# SERVICE BULLETIN

No. 567

Piper Aircraft Corporation

Subject: Flap Solenoid Repositioning

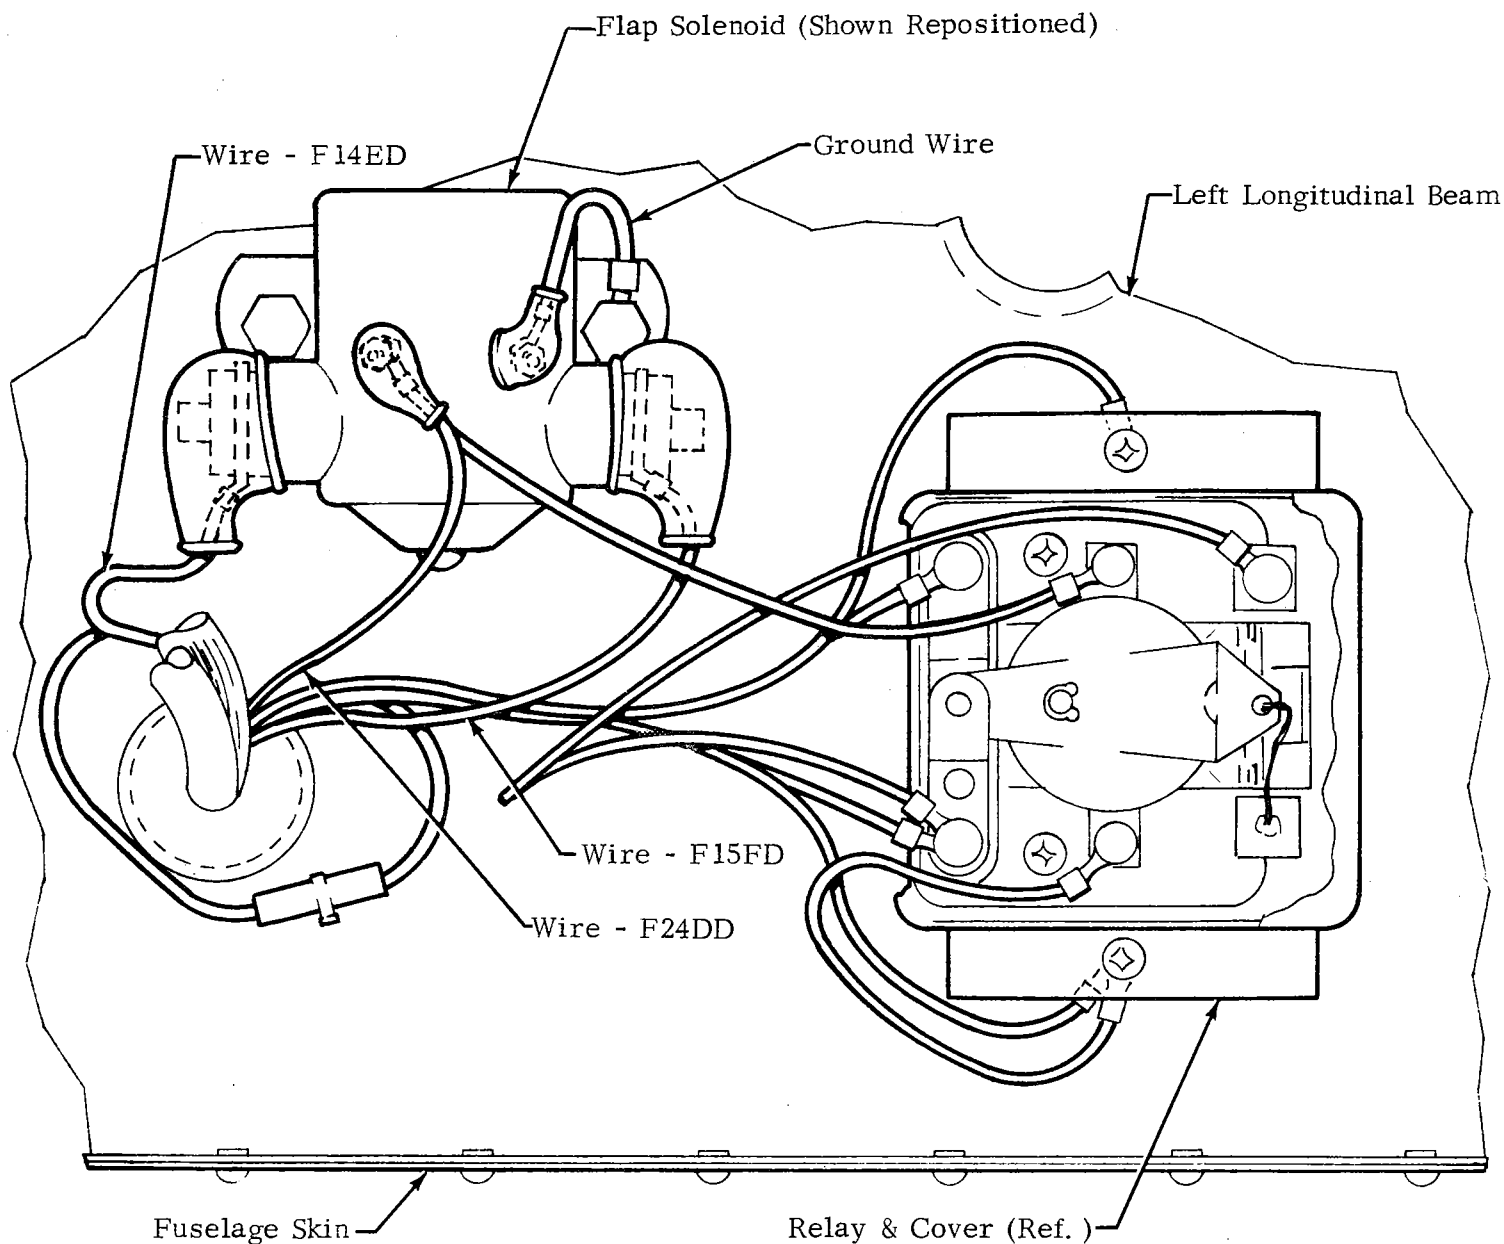
Purpose: The potential exists for the aileron balance cable to contact an electrical terminal on the flap solenoid. If the aileron balance cable should contact an exposed flap solenoid terminal, the flap system may become inoperative and/or the aileron balance cable may be damaged.

The Service Release contains instructions to invert the flap solenoid to preclude the possibility of the aileron balance cable contacting an exposed flap solenoid electrical terminal.

1. Refer to attached sketch/instruction data (to invert the solenoid).
2. Visually check aileron balance cable (near solenoid) for indications of damage; replace, if necessary.
3. Adjust position of solenoid terminal insulating boots (if necessary).

1. Remove the center floor panel from the main cabin area to gain access to the flap solenoid. Solenoid is located on the left longitudinal beam between the fuselage bulkheads at stations 162.60 and 174.00.
2. Remove the electrical wires from the solenoid.
3. Remove the solenoid from the beam and reinstall in the inverted position as shown above.
4. Reinstall the electrical wires to the solenoid.
5. Reinstall the center floor panel.
6. Make proper logbook entry of Service Bulletin compliance.
